SERVICE BULLETIN AMATEUR RADIO

SUBJECT TH-25AT/45AT AUTOMATIC POWER OFF FUNCTION	DATE 8/02/88
--	-----------------

FIGURE 5

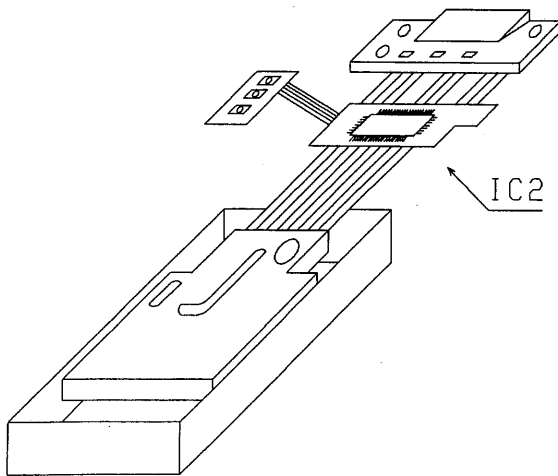
11. Carefully unfold the flex PCB to expose IC2 (FIGURE 5).
12. Using a 45 watt (or less) soldering iron that has an isolated or grounded tip, add a diode between pins 23 and 58 of IC2 (FIGURE 6).
